Size		Document Number		Rev	
CLOCK GEN(CK505)		PROJECT : ZA3		1A	
Date: Sunday, March 08, 2009		Sheet 3 of 34

Quanta Computer Inc.
PROJECT : ZA3

Model	REV	DATE	CHANGE LIST	NOTE
ZA3	A1A	20090107	PAGE16 : Reverse C301 R322 U19 R323 R324 for SPK AMP Power	ECN Release
		20090112	PAGE23 : Change PJ1 P/N and Footprint	
		20090113	PAGE18 : Del RN20 and add RN21 RN22 for HDD issues	
			PAGE18 : Add R325 for JMH330 XTAL issues	
			PAGE21 : Change CN4 P/N from DFFC24FR023 to DFFC24FR017	
			PAGE21 : Change CN4 footprint	
			PAGE20 : Change CN5 P/N from DFFC14FR080 to DFFC14FR047	
			PAGE20 : Change CN6 P/N from DFFC12FR293 to DFFC12FR019	
			PAGE17 : Change CN2 P/N from DFFC12FR293 to DFFC12FR019	
			PAGE20 : Change CN5 footprint from BL121-14R-TAND-14P-L-BU1 to af714l-n2g1x-14p-l	
			PAGE19 : Change ESD1 value to U20	
			PAGE16 : Change CN7 P/N from DFHS04FS969 to DFHD04MRA75	
			PAGE16 : Change CN7 footprint from 88460-0401-4p-l to 88266-040xx-xxx-4p-l	
			PAGE4 : Change CN7 P/N from DFHS04FS969 to DFHD04MRA75	
			PAGE4 : Change CN7 footprint from 88460-0401-4p-l to 88266-040xx-xxx-4p-r

CLK GEN & PWR

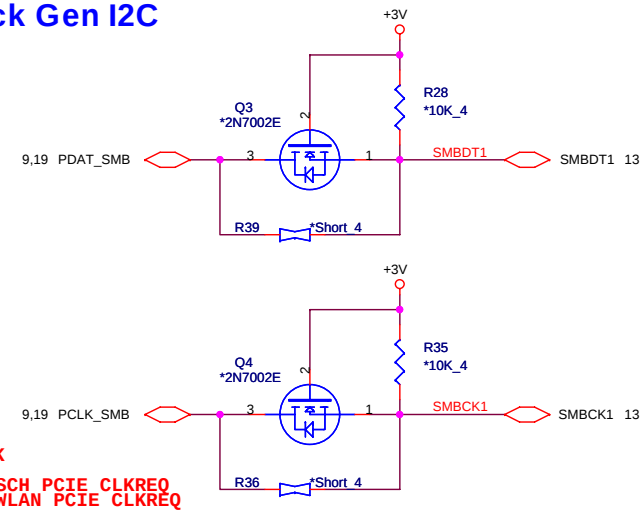
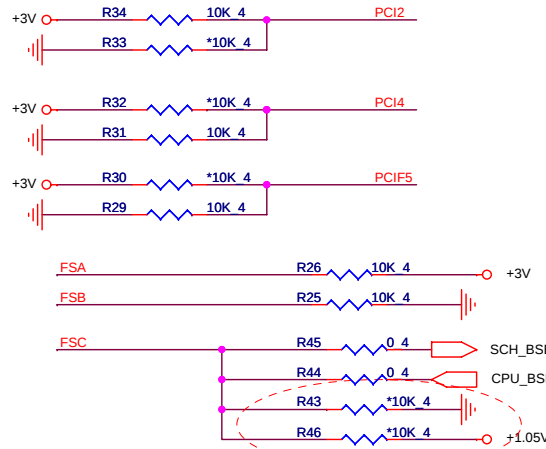
Modify R39 R36 footprint from RC0402 to SHORT0402 for 0 ohm cost down rev.c 20090301

Change R43 P/N from CS00002JB38 to CS31002JB28 rev.c 20090301

Poulsbo(CLG)

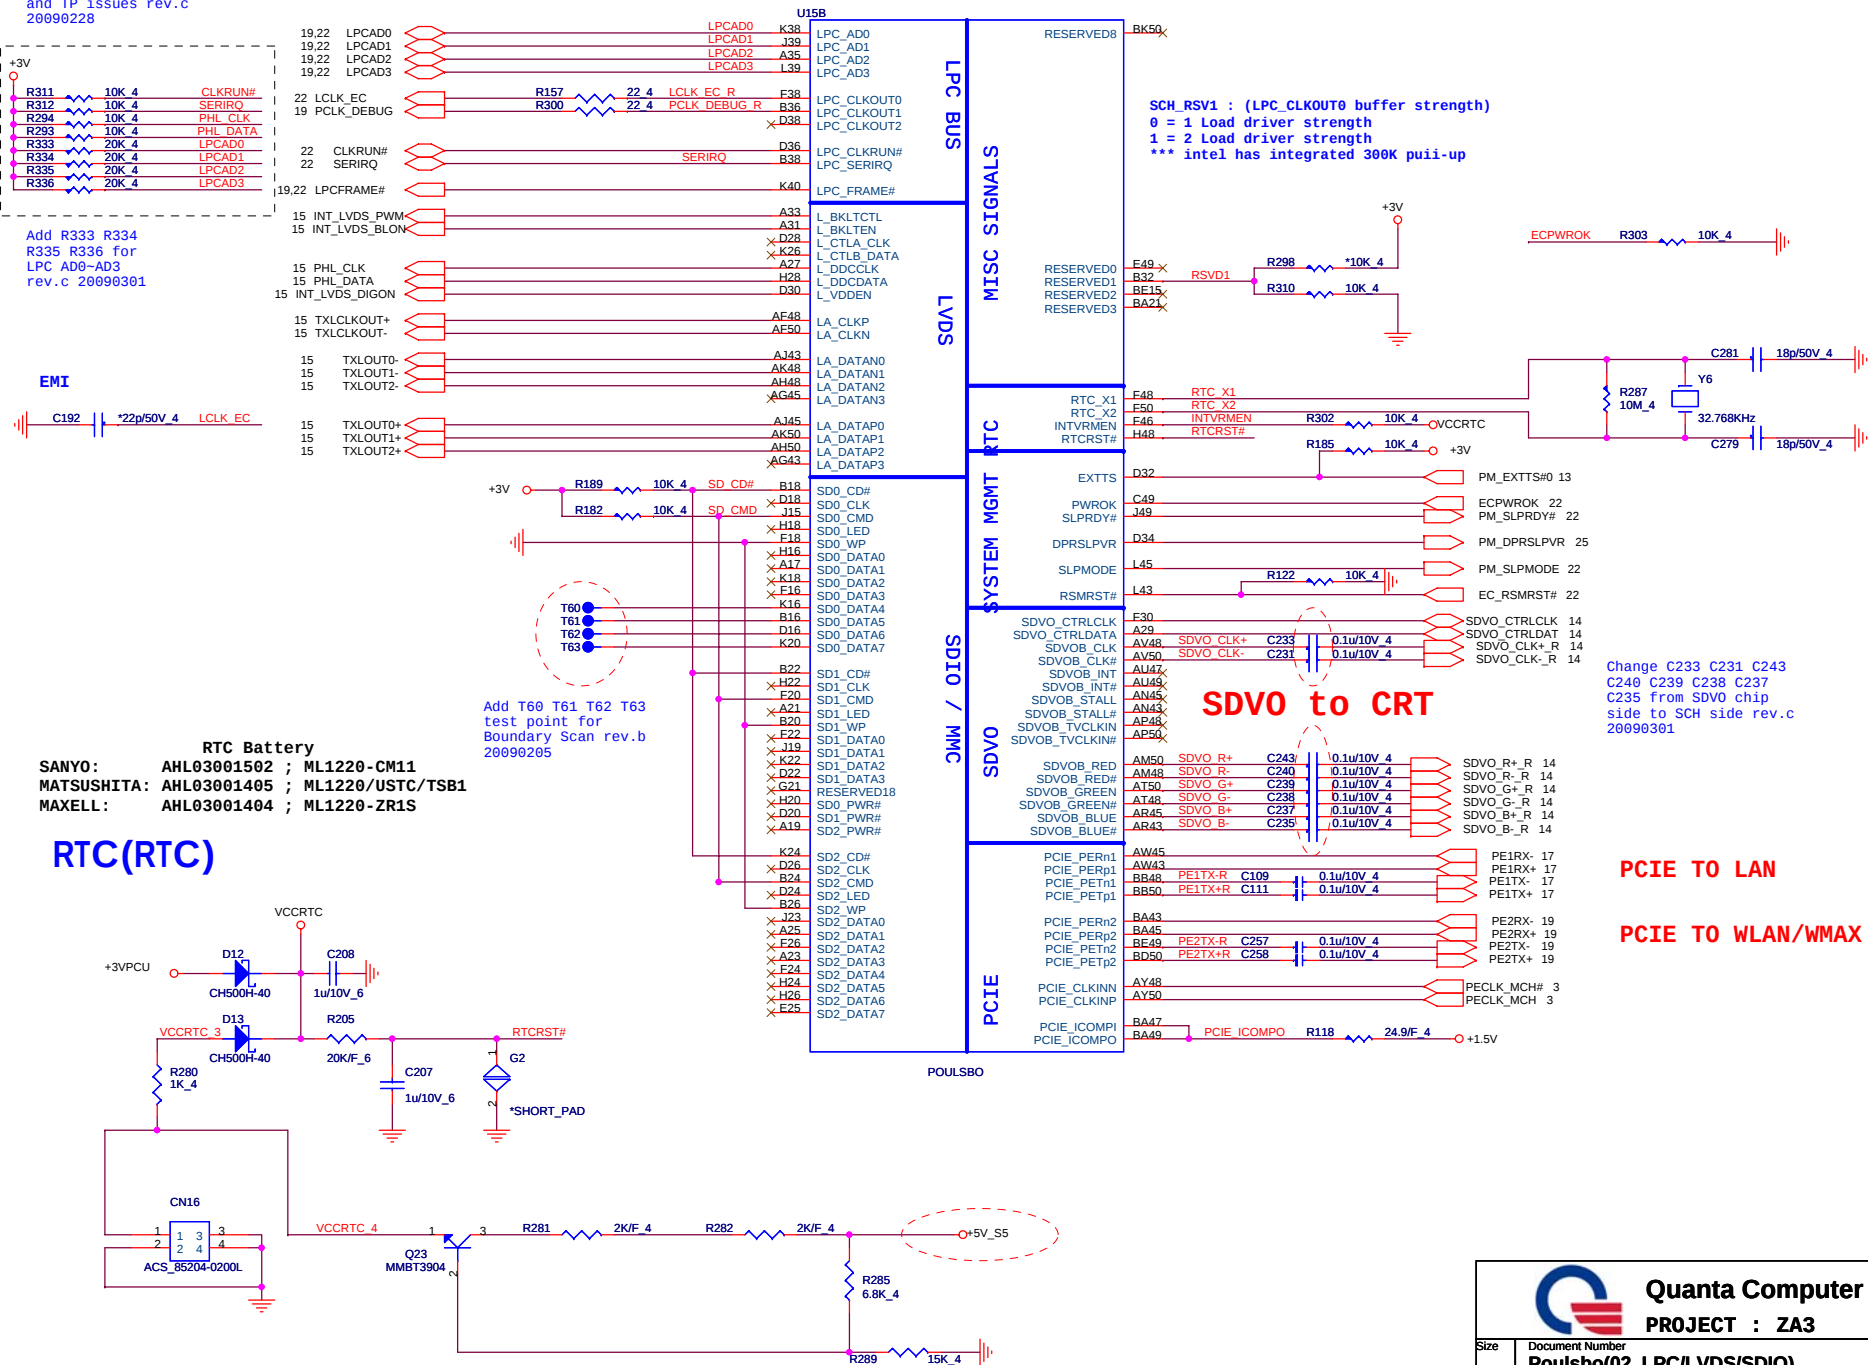
Stuff R312 for Keyboard
and TP issues rev.c
20090228

Size	Document Number	Rev
	Poulsbo(03_USB/PATA/HD)	1A
Date:	Sunday, March 08, 2009	Sheet 9 of 34

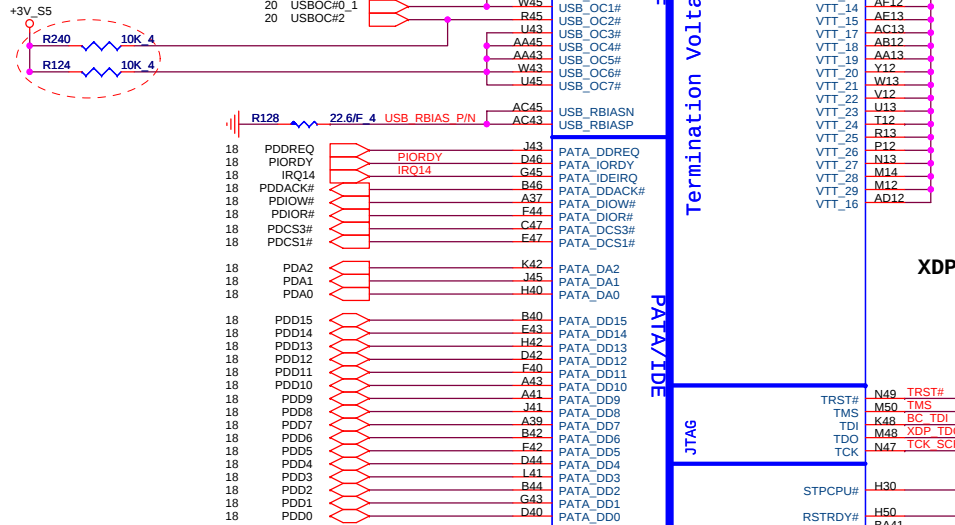
Change R186 R184 R309 R296
P/N from CS31002JB28 to
CS21002JB34 rev.c 20090301

Change R297 from
+3V_S5 to +3V
for SMI# rev.c
20090304

For intel suggest add R295 pull
down 20081218

Del RN8 and Add R337 R338 to SCH
SMBUS rev.c 20090301

DDR SYSTEM MEMORY

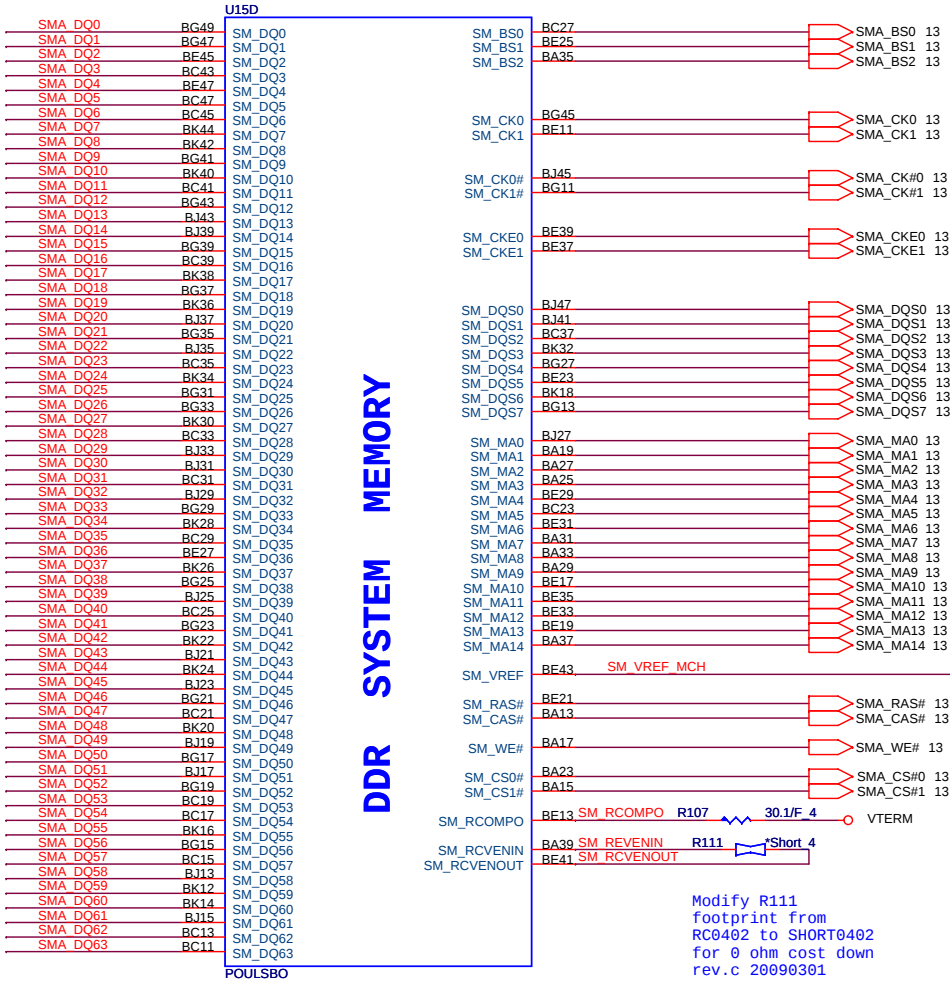
Modify R111 footprint from RC0402 to SHORT0402 for 0 ohm cost down rev.c 20090301

SDVO To CRT(CRT)

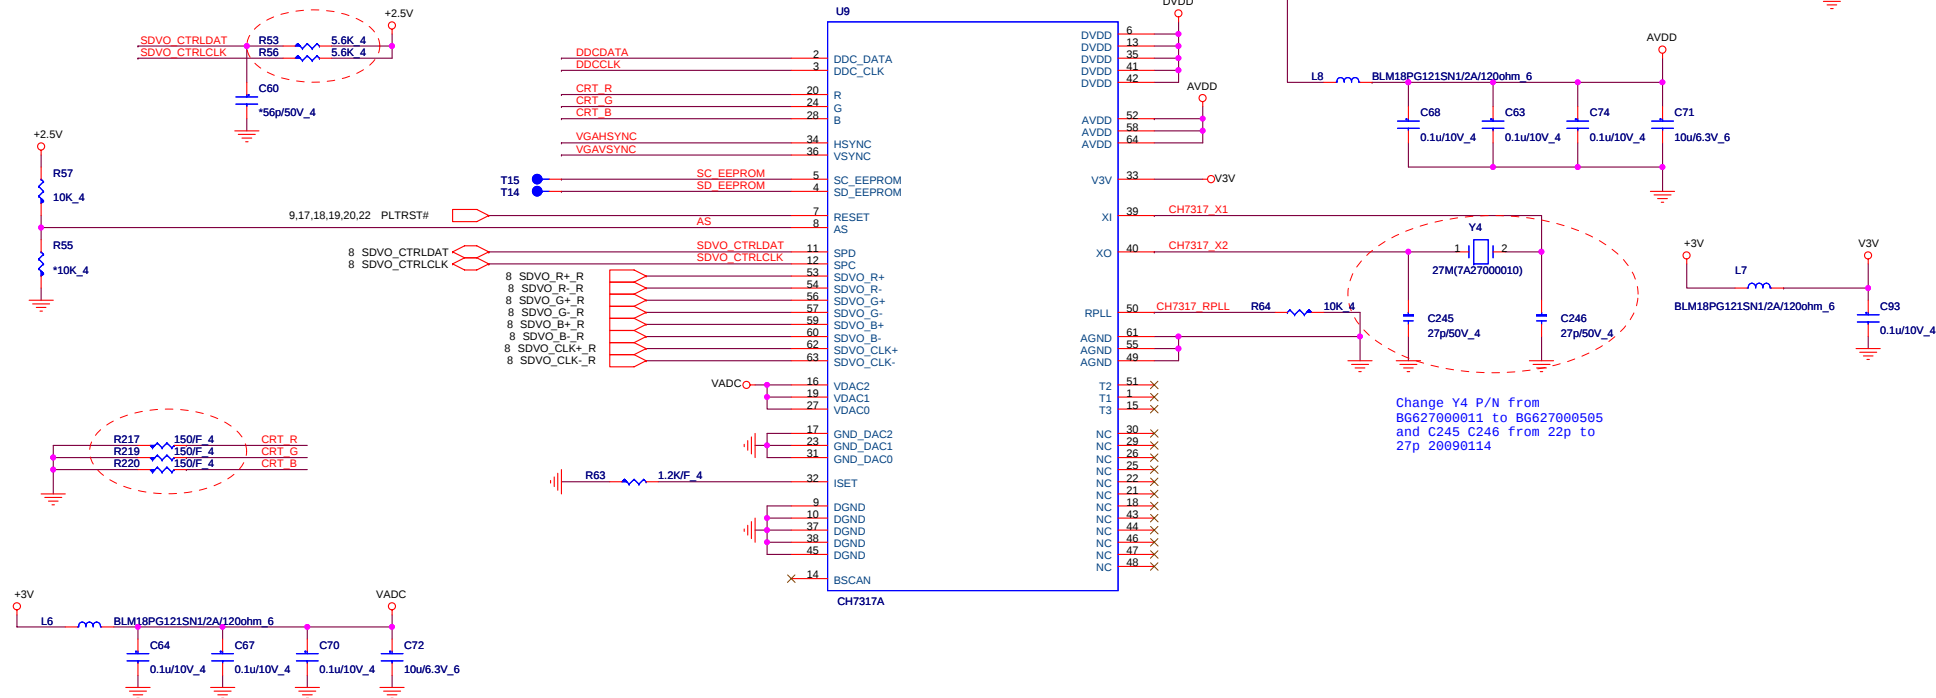
For vender FAE check, Change R53
R56 from 3.9K to 5.6K 20081205

Change Y4 P/N from
BG627000011 to BG627000505
and C245 C246 from 22p to
27p 20090114

CRT DB CONNECTER(CRT)

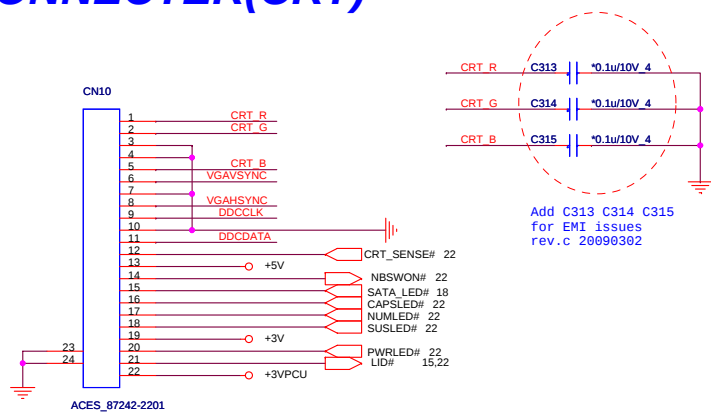
Add C313 C314 C315
for EMI issues
rev.c 20090302

BT CONNECTER(BTM)

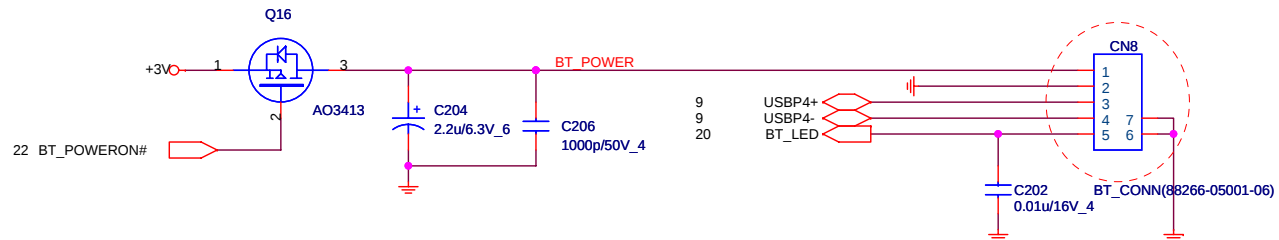
Modify CN8 footprint and pin define rev.c 20090301

HOLES

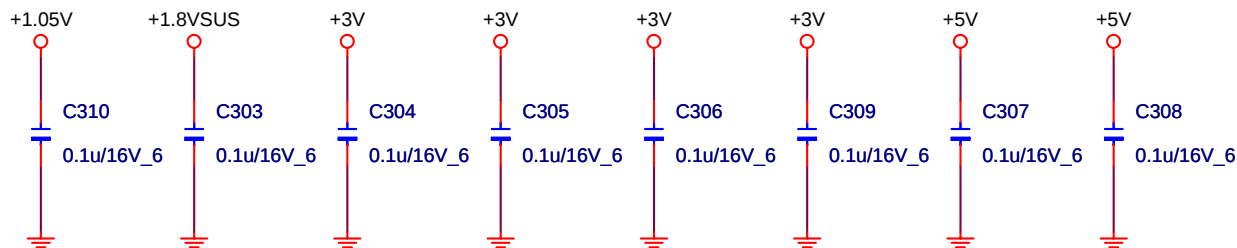
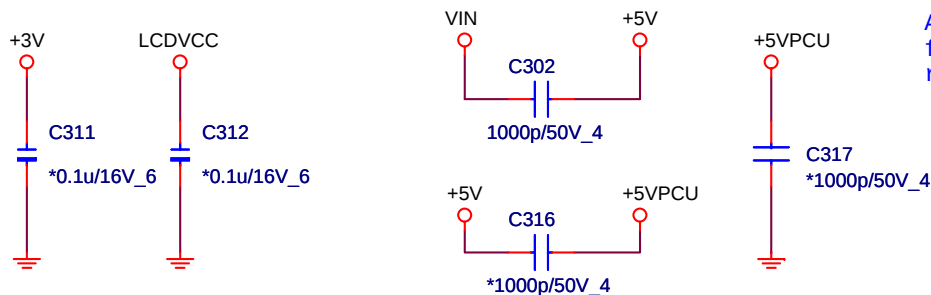
Add C303 C304 C305 C306 C307
C308 for EMI request rev.b
20090206 Add C309 C310 for
EMI request rev.b 20090207

Add C302 C316 C317
for EMI issues
rev.c 20090303
